REDACTED FINAL REPORT

Crude Oil Storage Tank 8 Maintenance Review

PWSRCAC Contract # 5056.20.01

William Mott P.E.

Figure 5 - Minimum Remaining Floorplate After 2019/2020 Repairs

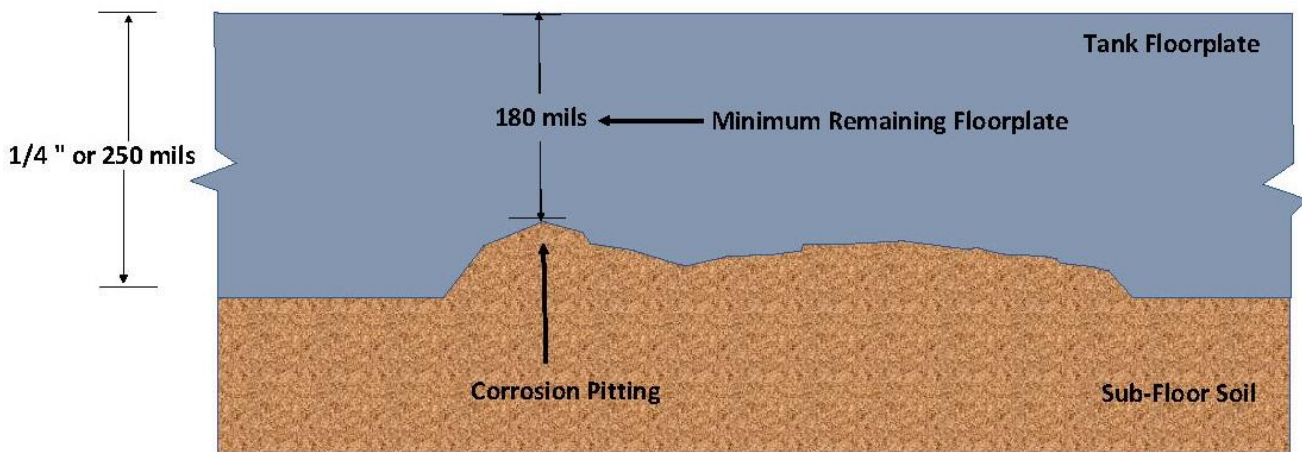
The Tank 8 floorplate is comprised of ¼-inch (250-mil) steel plate. The top surface is coated, and no topside corrosion was reported during the 2019/2020 internal inspection. After the 2020 repairs, the minimum remaining floorplate should be no less than 180-mils thick. Figure 5 shows how a cross section of the thinnest remaining (unrepaired) floor in Tank 8 might appear.

The code requires that the floor still have a minimum of 100-mils of thickness remaining at the end of the planned service interval. That left APSC's engineers an 80-mil corrosion allowance to bridge the 4-year period between the inspection (2019) and removal from service again (2023). APSC used a corrosion rate of 20-mils per year as justification to bridge the 4-year service interval.

Figure 6 - Predicted Minimum Remaining Floorplate in 2023

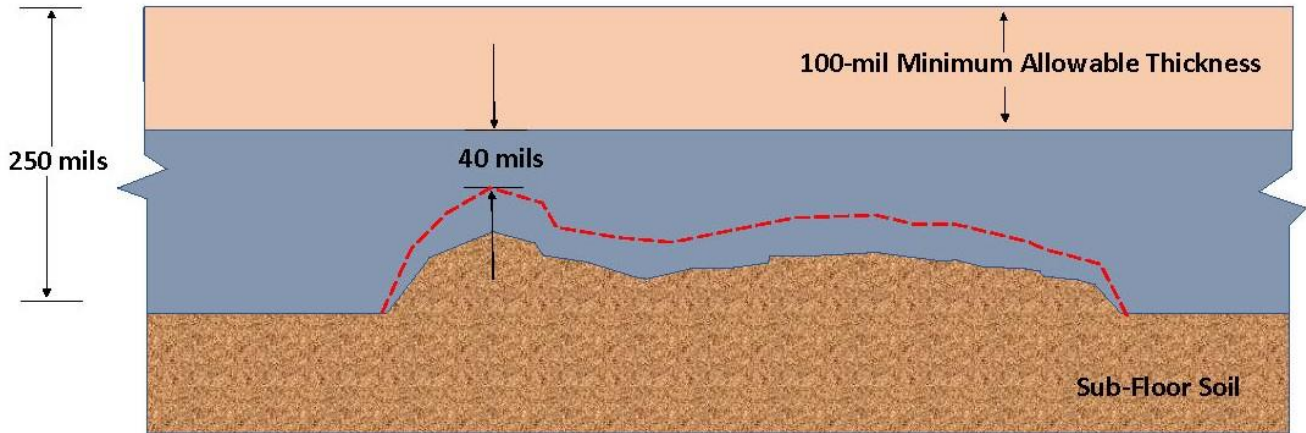
The actual corrosion rate experienced on the tank floor is closer to 11 mils-per year. The red dotted line in Figure 6 depicts the probable deepest pitting in the floorplate that will exist in 2023 (approximately 140-mils remaining wall thickness). The beige area represents the 100-mil minimum allowable floorplate thickness after the service interval.

APSC’s approach to the 2020 return-to-service is relatively conservative. The assumed corrosion rate of the service interval calculations is significantly higher than the measured rate. There is very little risk of a corrosion failure from Tank 8 before the tank is removed from service again in 2023.

Figure 8 - Annular Plate Extension (No Seal)

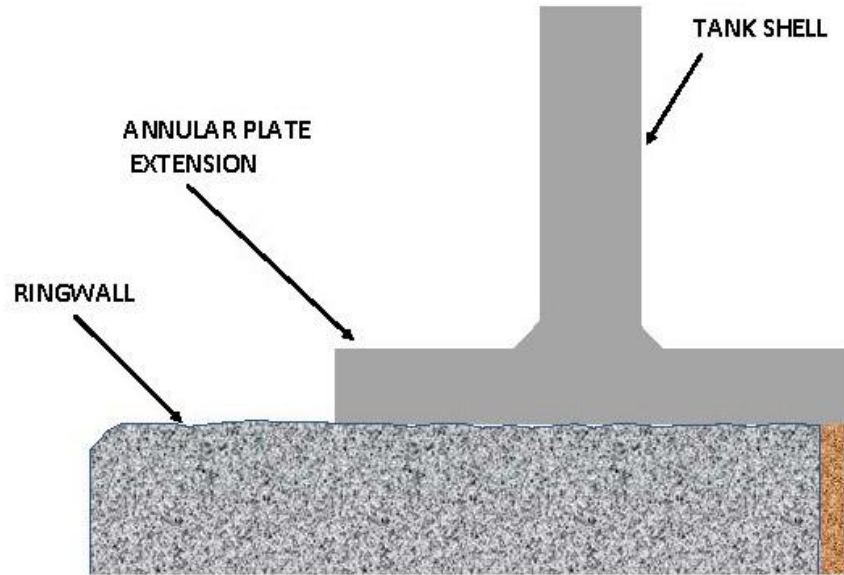
Figure 8 represents an enlarged section view of the area in the red circle from Figure 7. The tank annular plate extension (or floorplate extension) rests directly on top of the concrete ringwall. The floorplate extension is not sealed to the concrete ringwall. Any rainwater running down the side of the tank can collect on the top of the ringwall and either run off the outer diameter of the foundation or seep under the annular plate extension and into the soils between the floorplate and secondary containment liner. This can exacerbate corrosion of the tank

floor and potentially lead to buoyancy forces pushing up on the tank floor and damaging it and/or the tank roof column supports – which is discussed in detail later.

APSC should drain as much water as possible from beneath the tanks through the available drainage piping and CP monitoring tubes. They should replace and maintain the ringwall/floorplate seals to prevent further water intrusion beneath the floors of storage tanks at the VMT.

Figure 11 – Cracked Ringwall/Annular Plate Seal

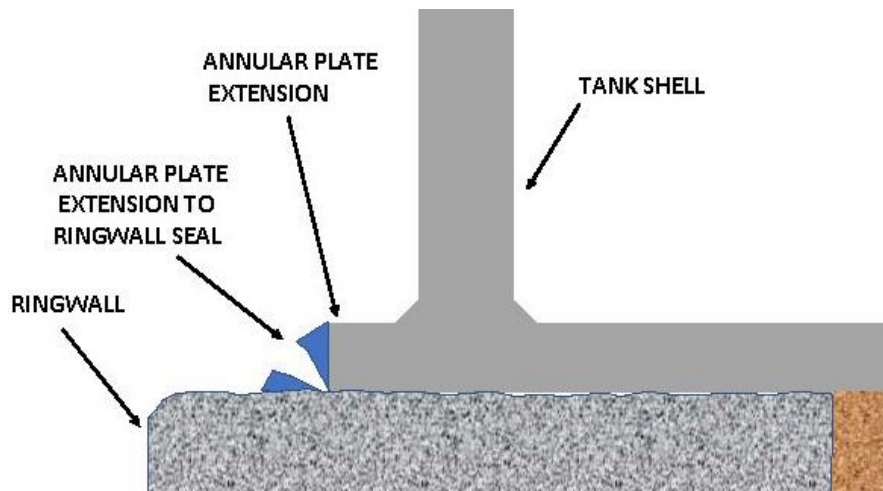
Rather than preventing water from seeping beneath the tank floor, the cracked seals may be exacerbating the water migration into that area. Figure 11 depicts a section of the ringwall/annular plate with a cracked seal. The presence of a crack in that joint forms a gap that may funnel more rainwater beneath the floor than would be caused by the lack of any seal.

Figure 12 – Tank Sump Flotation

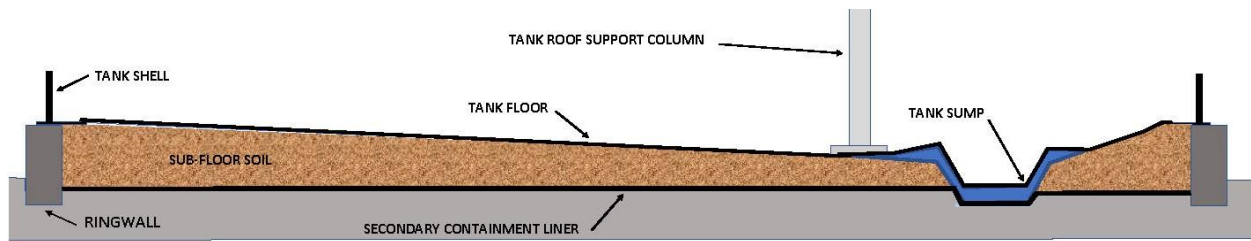
Water-saturated soils beneath the crude tanks increase the risk of bottomsides corrosion and impart buoyant (upward) forces on the tank sump and surrounding floorplate. When the tank is fully emptied of oil, these forces can cause the sump to float and be displaced vertically (Figure 12). There are four roof support columns in relatively close proximity to the sump. Any upward motion of the sump can cause high stresses on the adjacent columns, risking damage to the floor or column footing.

Figure 13 – Subfloor Drainage System Location

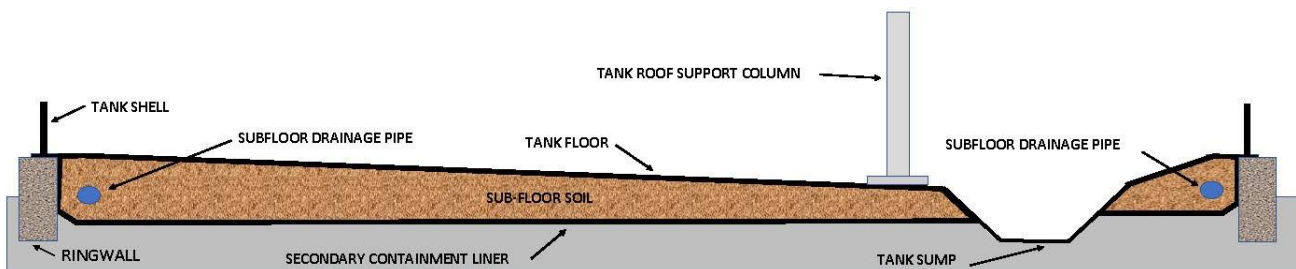
On some of the crude storage tanks, APSC installed subfloor drain piping between the tank floor and secondary containment liner (Figure 13). We have not received a record of exactly which tanks have that drainage system. However, the drain piping was installed at a level that is significantly higher than the bottom of the tank sump. While the drain piping will reduce the buoyant forces acting on the sump, it will not totally alleviate those forces.

Figure 17 – 2001-2006 Average Change in Tank 8 Depolarized Potential Readings

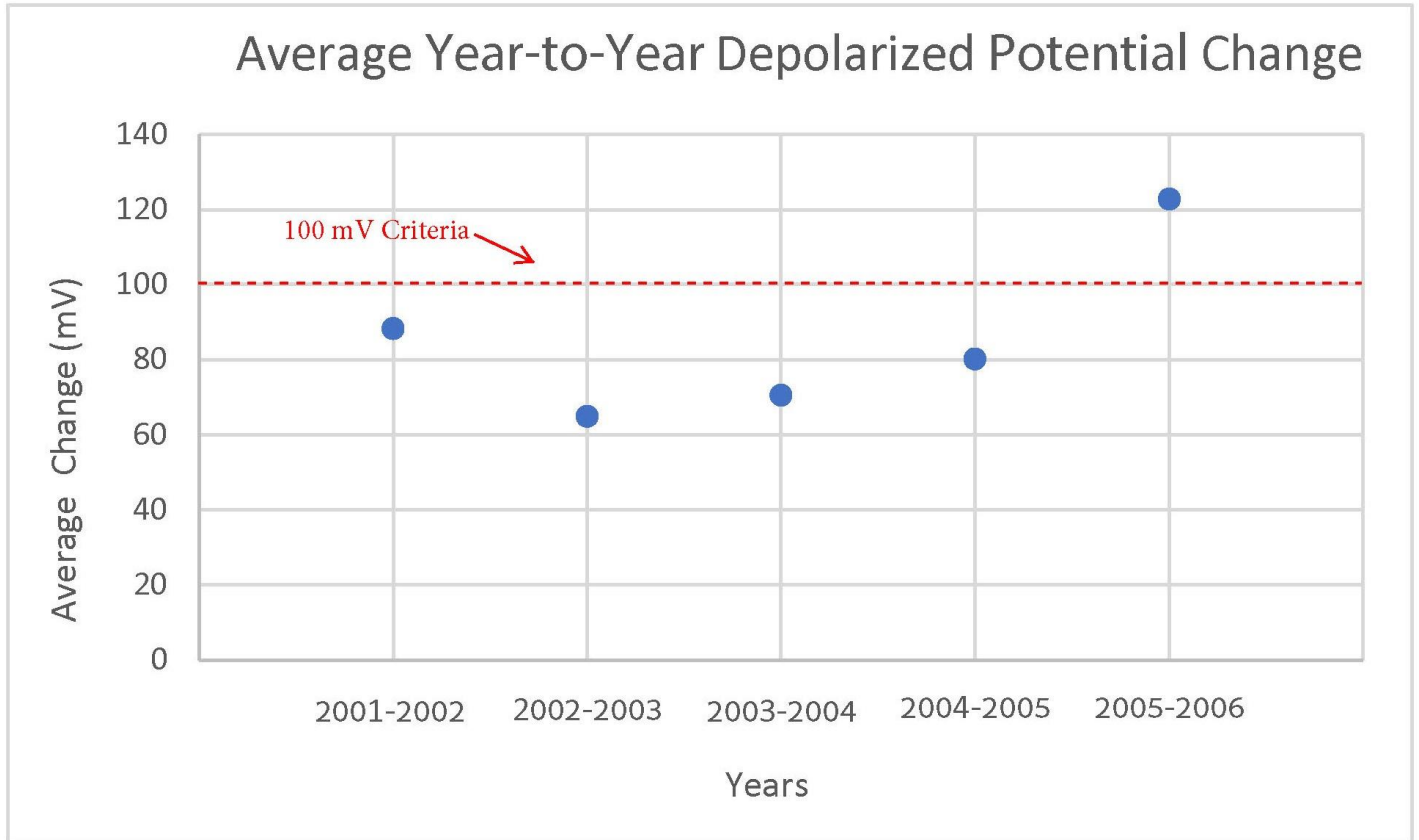
Figure 17 presents a graph of the 2001-2006 year-to-year average change in depolarized potentials for Tank 8. A line showing the 100 mV criteria was added to the graph for reference. This clearly illustrates that the annual changes in the depolarized potentials on the tank are similar in magnitude to the criteria that is being measured against. In fact, between 2005 and 2006, the average change in depolarization potentials was greater than the 100 mV criteria that is being measured against.

Figure 18 – Subfloor Anode/Monitoring Tube Locations

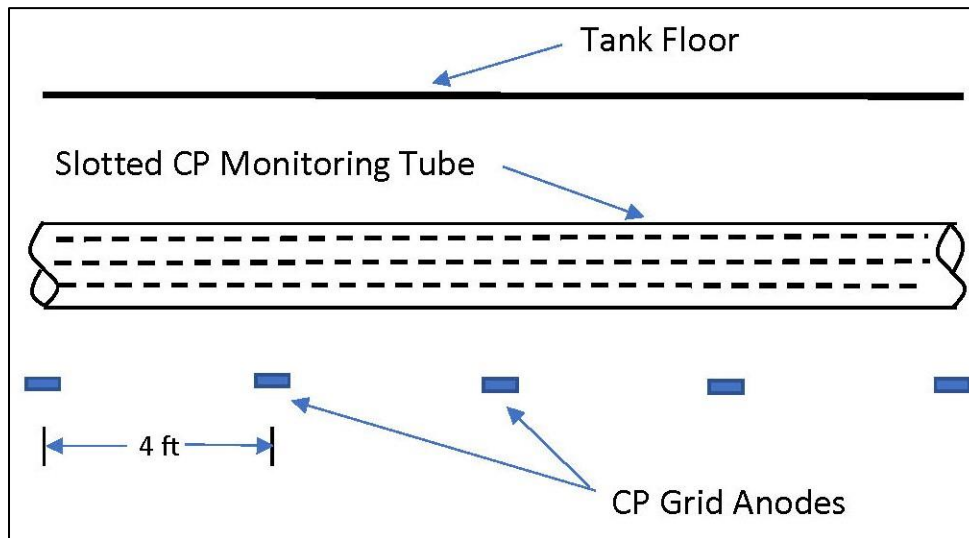
Regardless of the cause of the error, this statement is basically saying that the very negative readings include an inherent error and are invalid. If the proximity to the anode grid wires was the cause of the error as suggested by the APSC, then to collect accurate data, the operator would have to know precisely where the reference cell was in relation to each anode grid wire and they also would have to determine the minimum distance between the reference cell and anode grid wire that is necessary to collect accurate data. Figure 18 (below) is intended to depict the relative locations between the MMO anode grid wires, the slotted CP monitoring tube, and the floorplate. The CP reference cell is run beneath the tank through the slotted CP monitoring tube and data is collected at set distances from the tank shell. As can be seen from Figure 18, the reference cell will always be within 2-feet of the anode.

Figure 19 – CP Reading Error/Distance from Anode

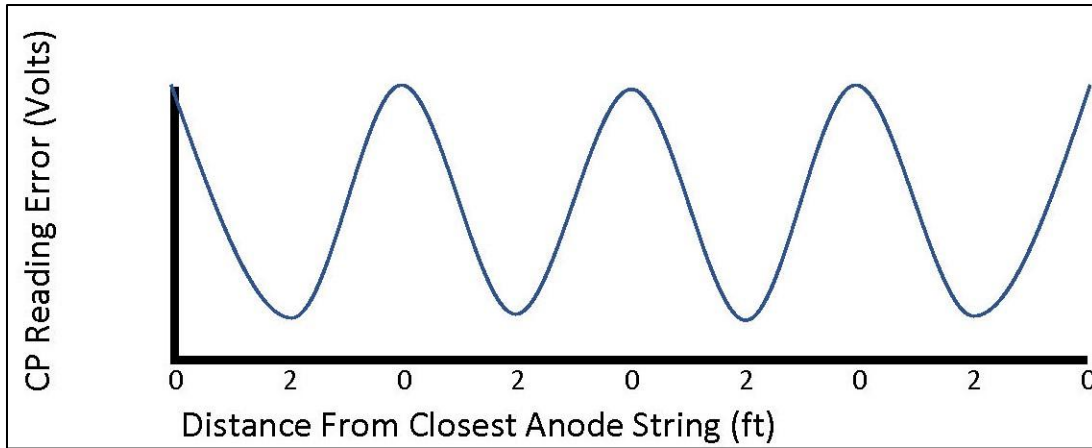
If the CP reading errors were caused by proximity to the anodes, then the magnitude of that error would gradually decrease as the distance from the anode increases. This decrease would continue until the reading was taken at the midpoint between two anode wires (as depicted in Figure 19), at which point the error would begin to increase again. If APSC's statement regarding proximity to the anode is accurate, this means that all CP readings collected beneath the tank are likely to be impacted by the same causal error, although the magnitude of that error may vary relative to the distance from the anode.

In our professional opinion, the reasoning for the error that is cited may not be entirely correct. If all impacting CP systems are properly interrupted, then the field around the anode should collapse and the potential readings should not be impacted by the relative proximity to the anode.

Figure 21- Tank 8 Repair Patch Locations

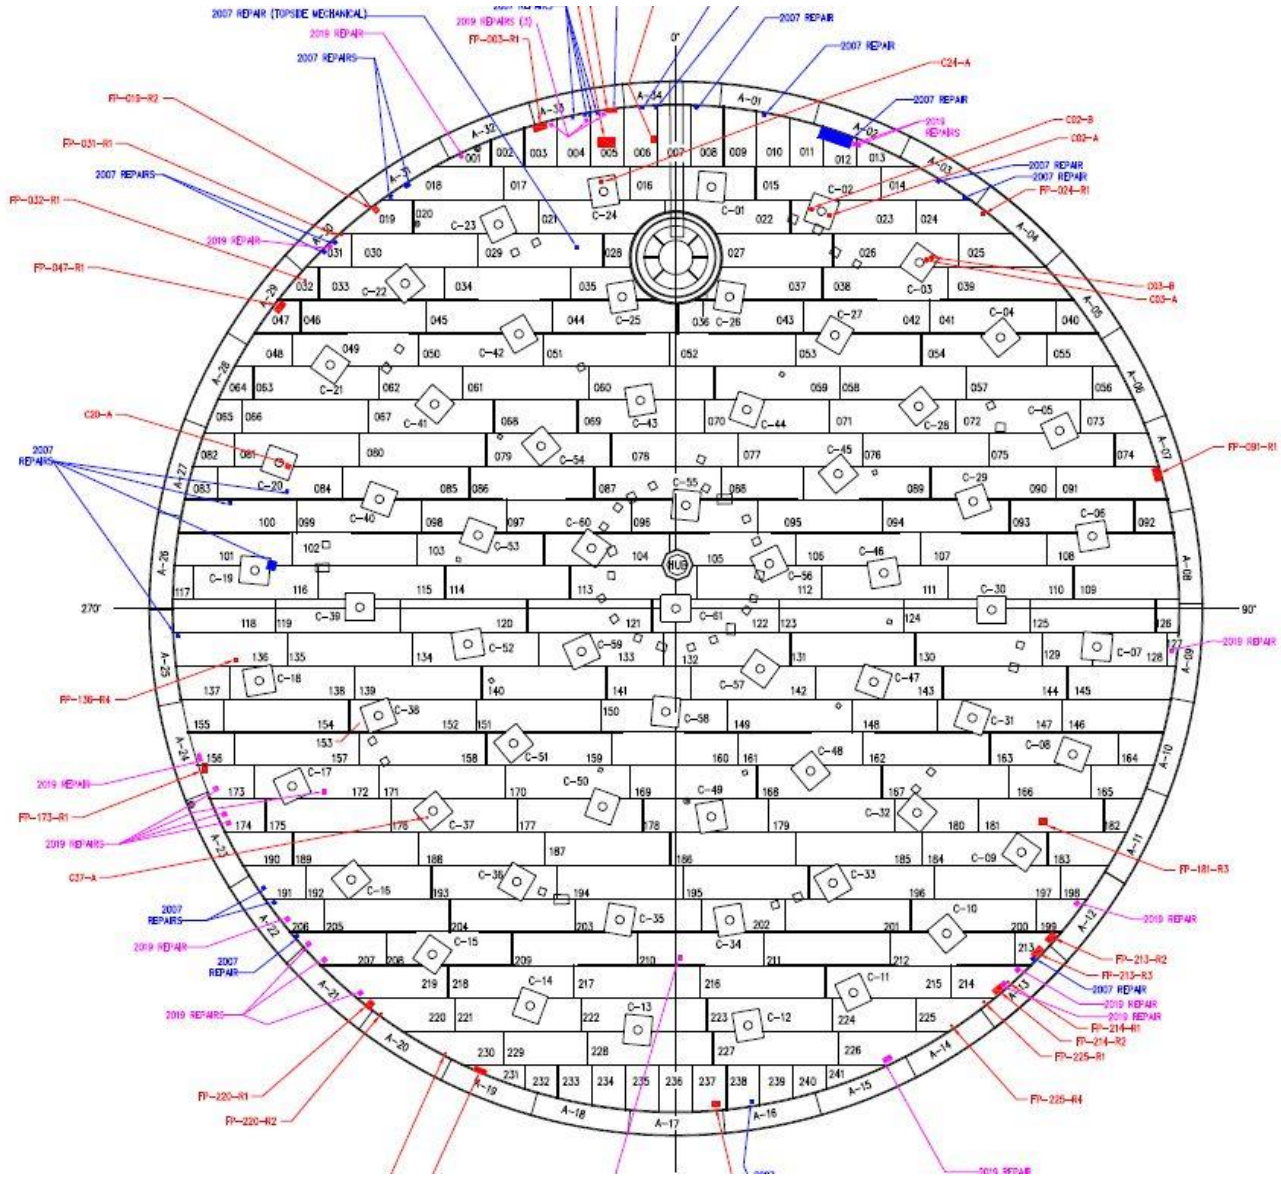
The tank CP system design does not appear to have maintained a consistent distance between the tank floor and the anode grid. The anode material was to be maintained at least 18 inches from the annular plate and at least 12 inches from the sump.⁸ The inconsistent anode offset from the floor makes maintaining even current distribution across the floor much more difficult. This configuration would suggest that the CP current density afforded the outer perimeter floor plates would be roughly 50% lower than the CP current density afforded the floorplates near the sump.

The design also did not include the installation of CP ribbon beneath the annular plate. That suggests that some of the current intended to protect the perimeter floorplate will instead be picked up by the annular plate, further reducing the protection of the perimeter floorplates.

This may be in part why the majority of the floorplate repairs completed in 2007 and 2019 were located on the perimeter plates of Tank 8 (Figure 21).

- A. The replacement cathodic protection system should include a groundbed that is a consistent distance from the floorplate to ensure more uniform distribution of CP current.
- B. The replacement CP system should also have the ability to adjust the groundbed circuit resistances or driving voltage, in perimeter areas, so that the levels of CP current can be balanced across all areas of the tank floor. This can be done with the installation of a separate groundbed and rectifier in the perimeter areas.
- C. CP monitoring tubes beneath the tanks should be slotted through the area beneath the annular plate so that levels of CP in those areas can be adequately monitored.
